WT Young Library Renovation

PROJECT 3050.1

ADDENDUM #6

**WT YOUNG LIBRARY
LOWER LEVEL RENOVATION**

A-601
COPYRIGHT 2026 - JRA, INC.

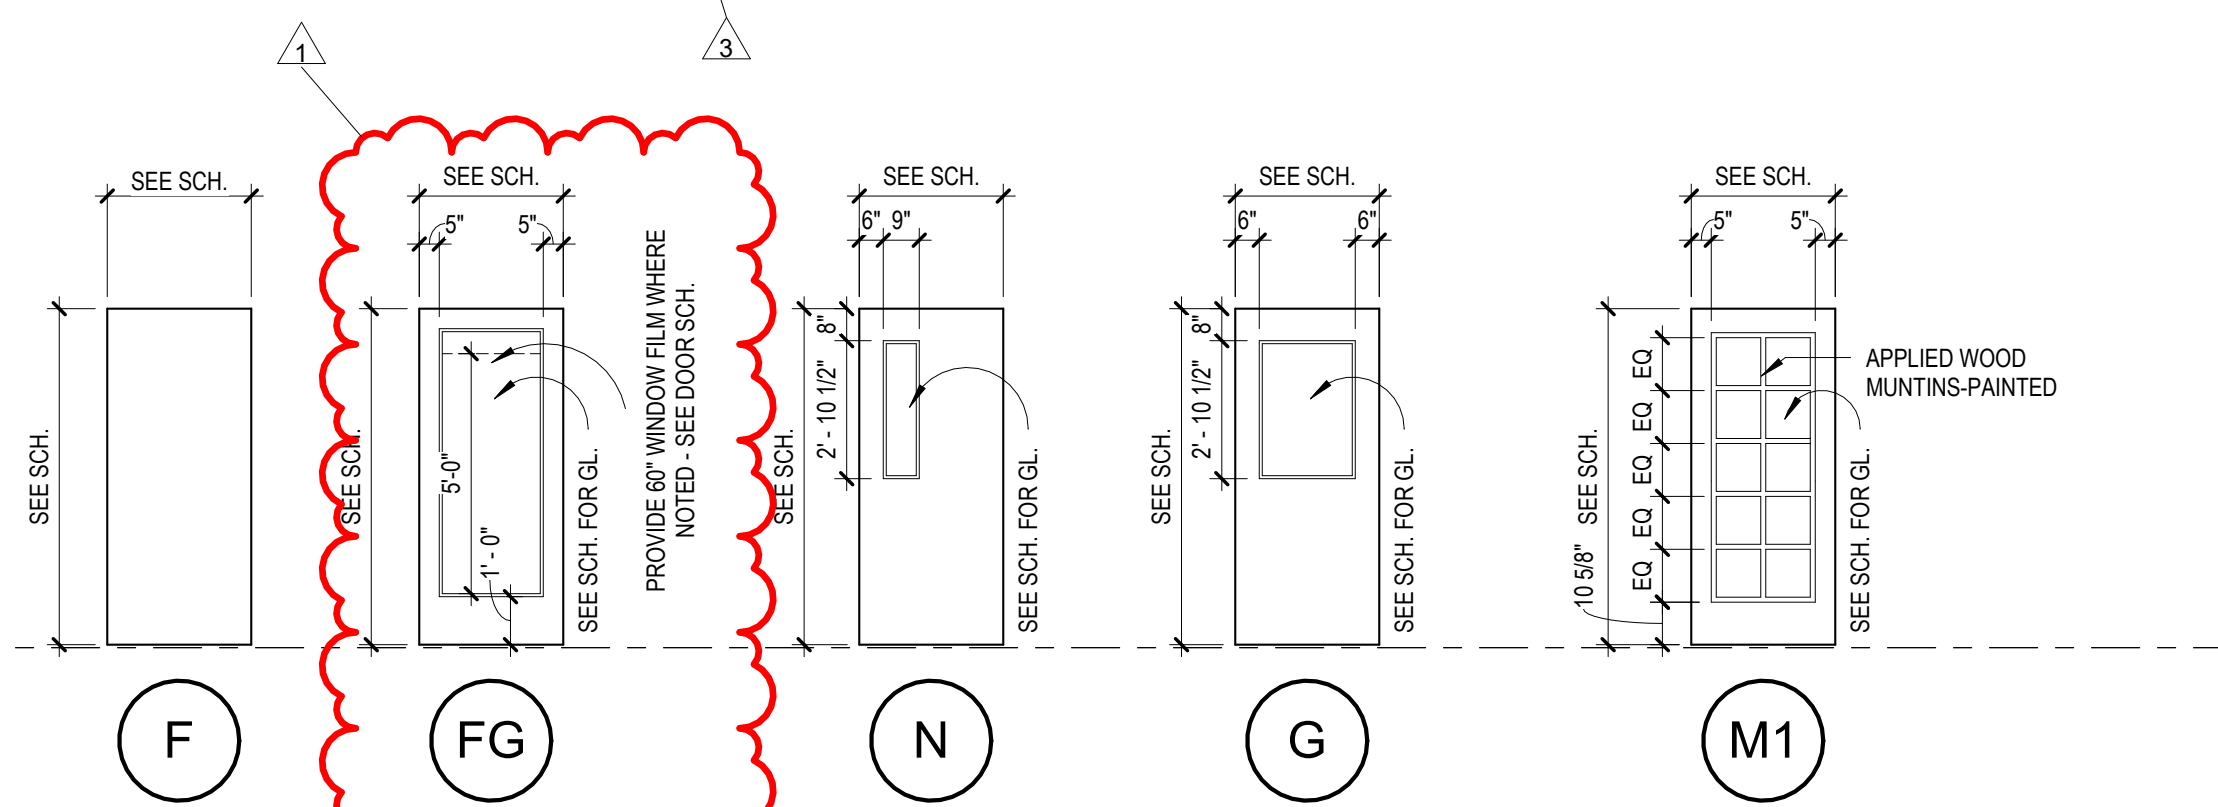
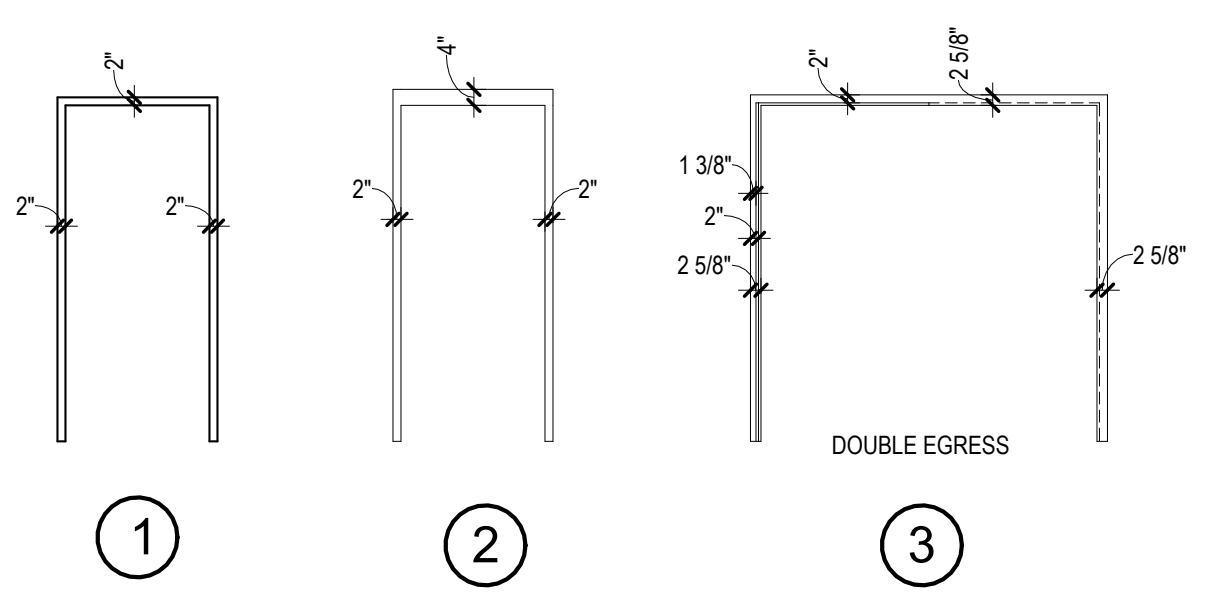
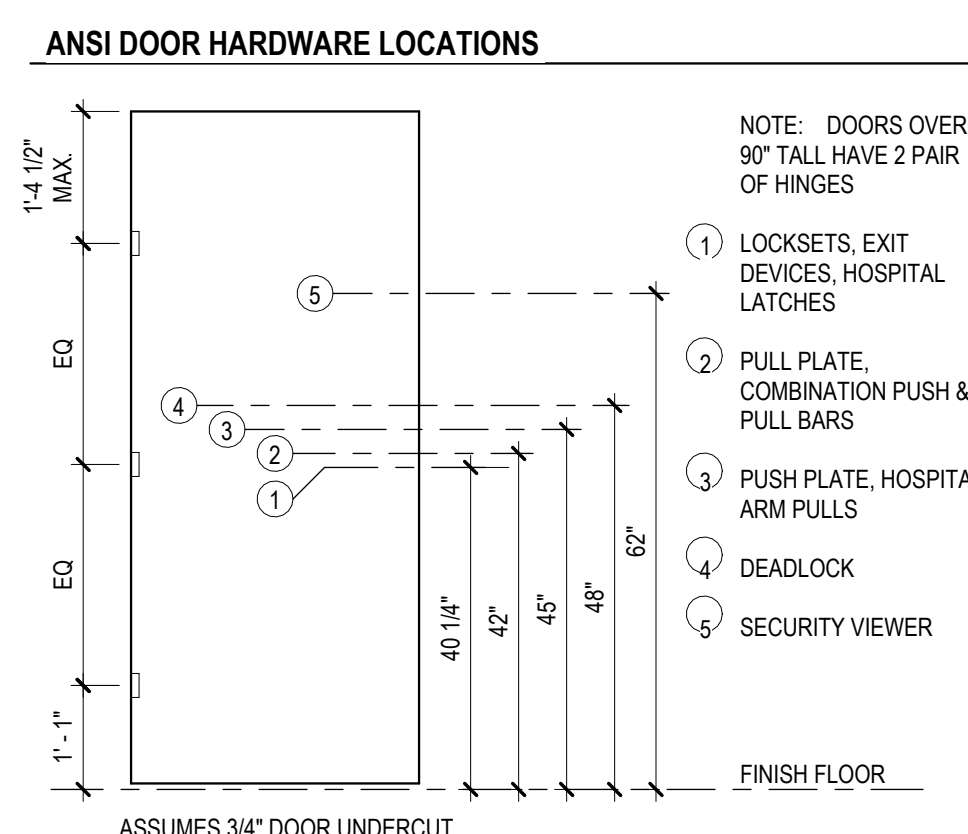
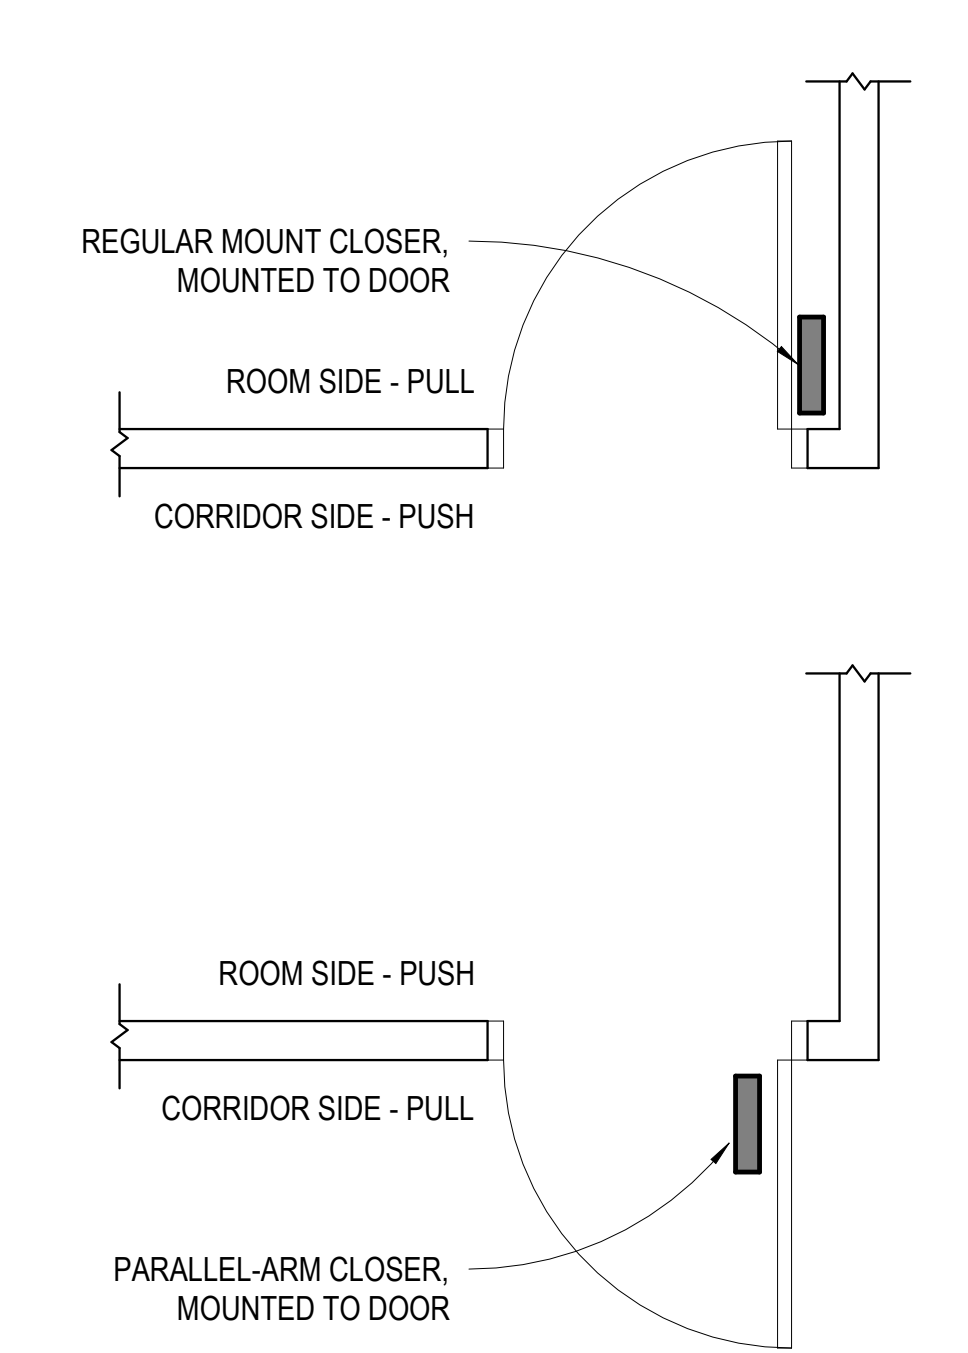
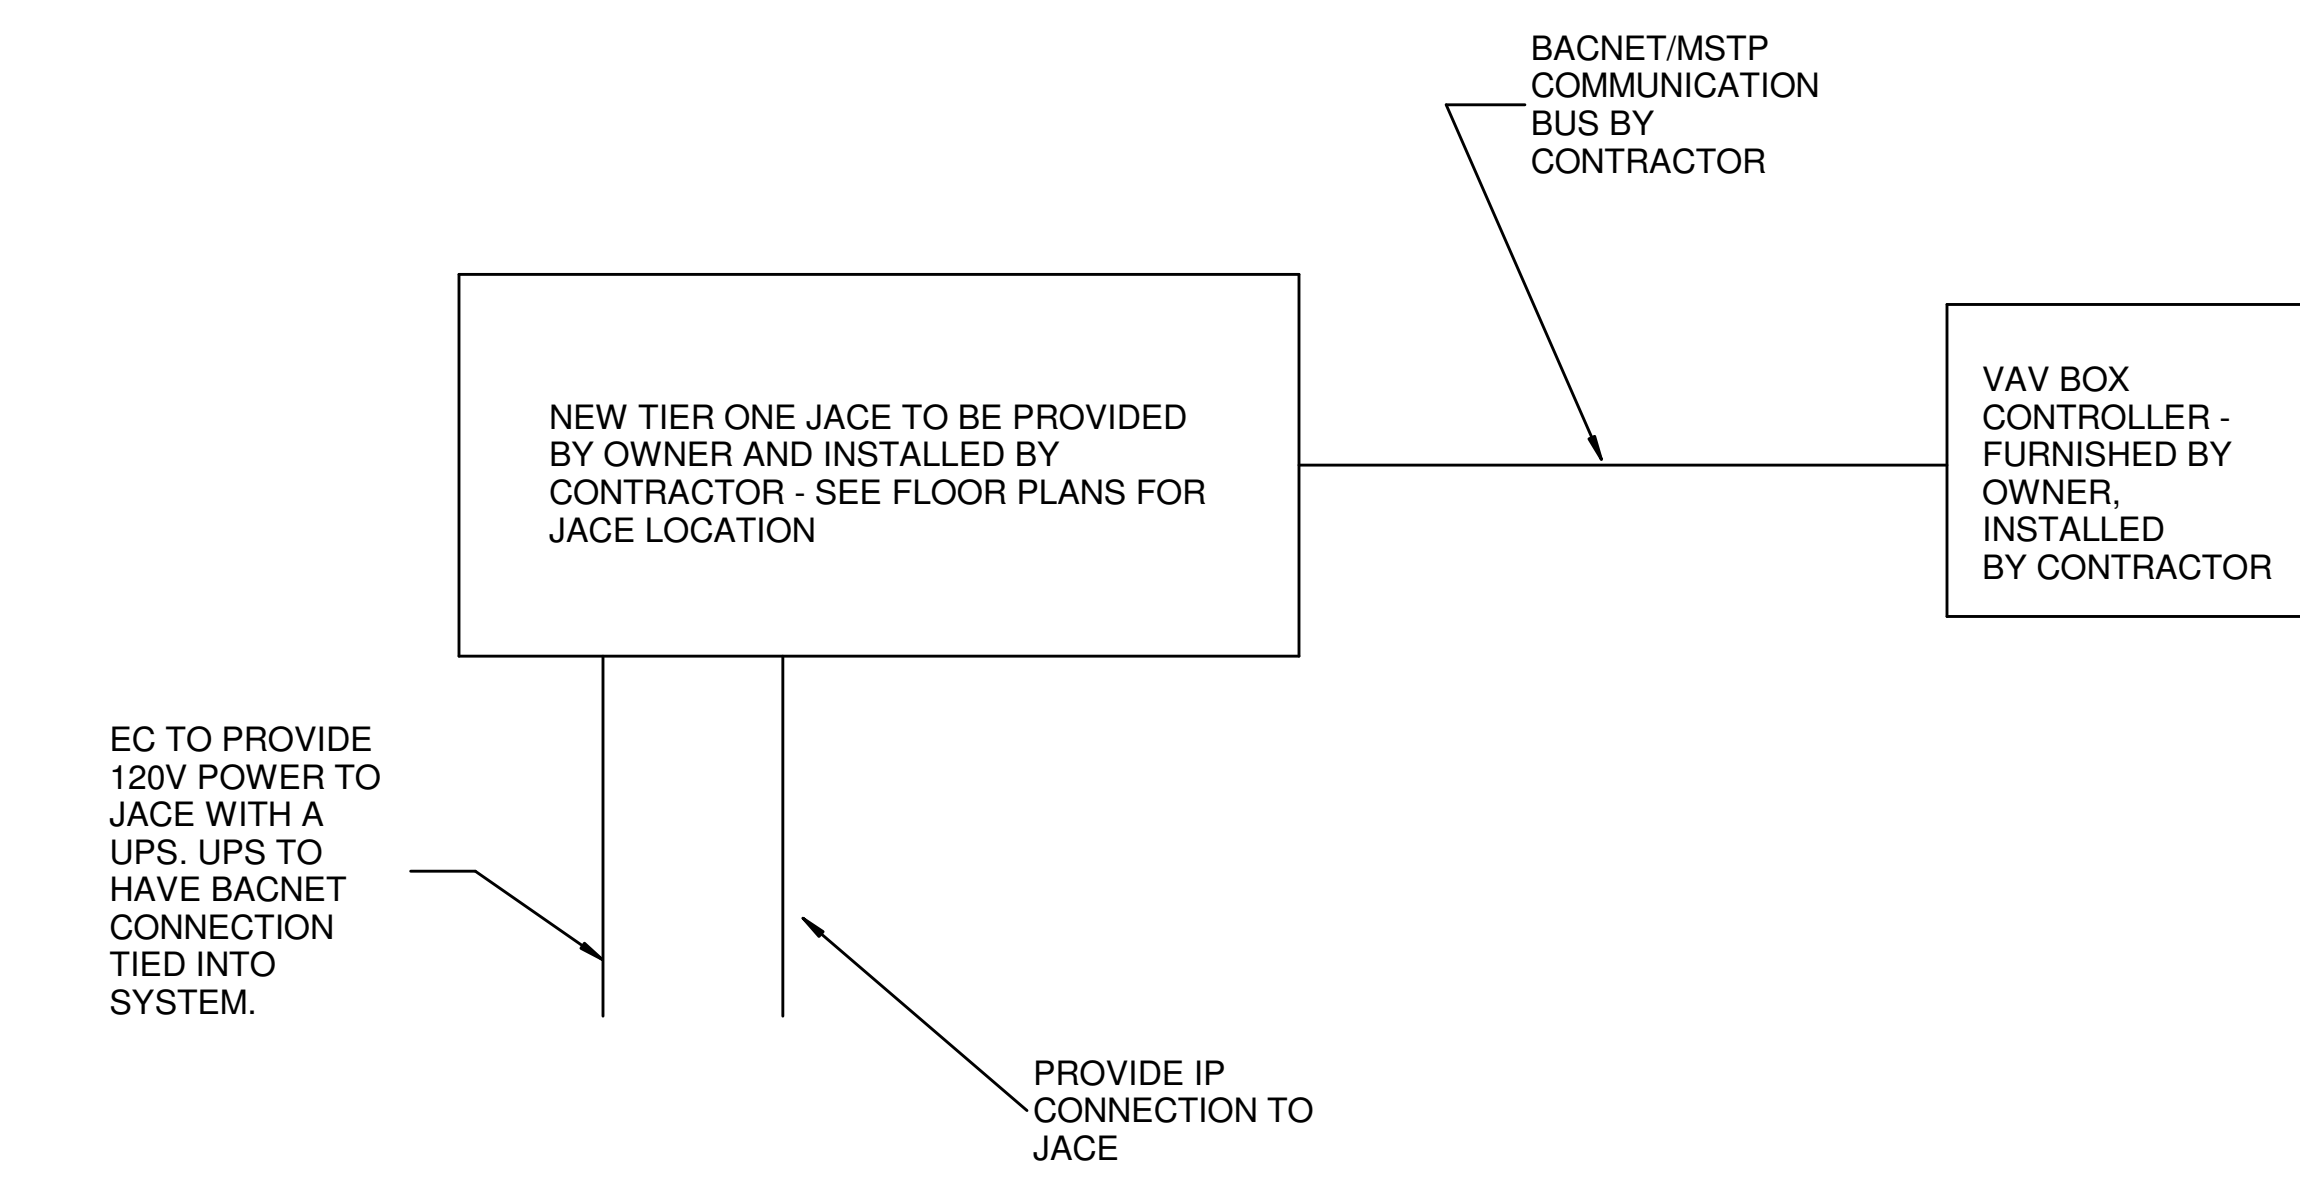
<p>On Door Schedule A-601, Opening (B68) does not have Frame Material or Frame Type marked. Could you please verify what Frame Material and Frame Type this opening needs?</p>	<p>HM</p>
<p>On Door Schedule A-601, Openings (B23, B28A, B28B, B29, and B66) do not have HW Set #. Could you please verify what HW Set #'s these openings should be?</p>	<p>B23 C01C, B28A CE01A, B28B CE01A, B29 C01E, and B66 C01C</p>
<p>On Door Schedule A-601, All openings do not have assigned Frame Type's. Could you please verify what Frame Type's each opening should be?</p>	<p>All are frame type 1, unless noted otherwise</p>

- Refer to reissued sheet A-601 attached. Door type FG was revised to show only 60" coverage of window film in lieu of full glass coverage.
